RNTPC Paper No. A/NE-LYT/868A

**Application for Planning Permission for
Proposed Temporary Warehouse for Storage of Construction Materials and Associated
Filling of Land for a Period of 3 Years at Lots 1445 S.B ss.2, 1445 S.B RP, 1489, 1490, 1492
and 1494 in D.D. 76 and Adjoining Government Land, Ng Uk Tsuen, Sha Tau Kok Road,
Ma Mei Ha, Fanling, N.T.**

(Application No. A/ NE-LYT/868)

Table 1: Responses to Comments from Fire Services Department on Planning Application No. A/NE-LYT/868 (16 March, 2026)

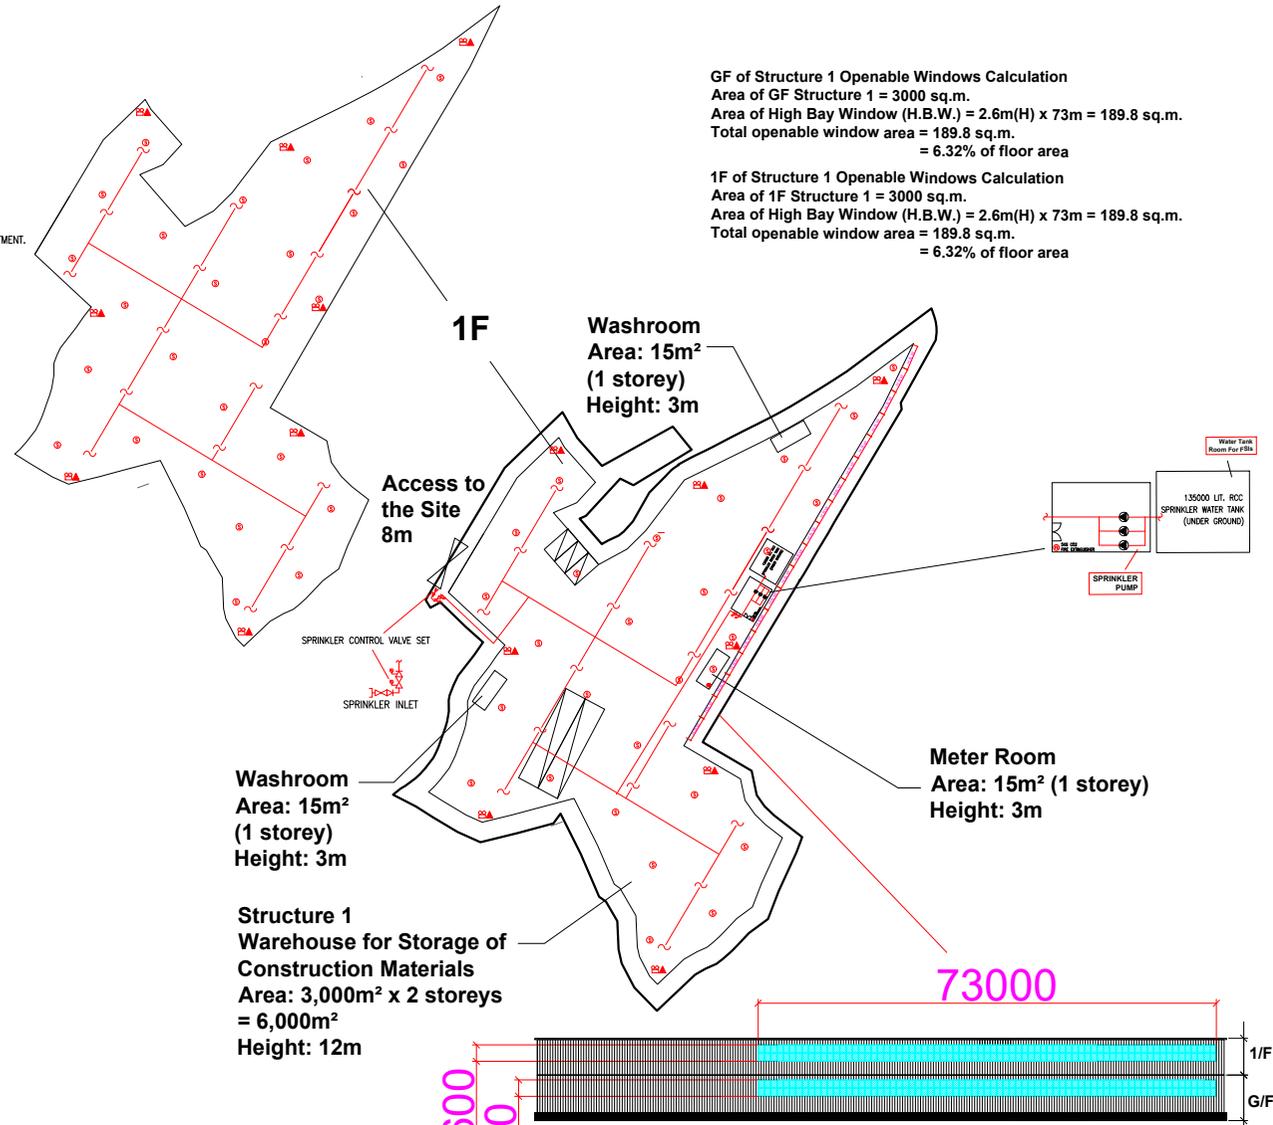
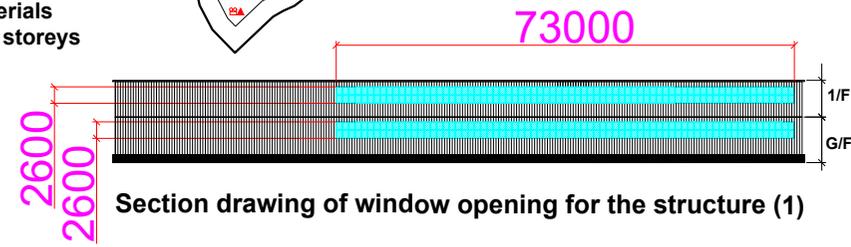
COMMENTS		RESPONSES	
1.	Fire Services Department (Contact Person: Mr. LI Chi-fung; Tel: 2733 5844)		
	Based on the revised fire services installations (FSIs) proposal, he has the following comments:		
(1)	According to FSD Circular Letter No. 5/2020 (https://www.hkfsd.gov.hk/eng/source/circular/2020_05_eng_20200911_151307.pdf), the sprinkler inlet and control valve shall be located in a prominent position on the exterior of the building, near the entrance.	(1)	The sprinkler inlet and control valve will be provided in a prominent position on the exterior of the building, near the entrance (see the revised FSIs proposal attached).
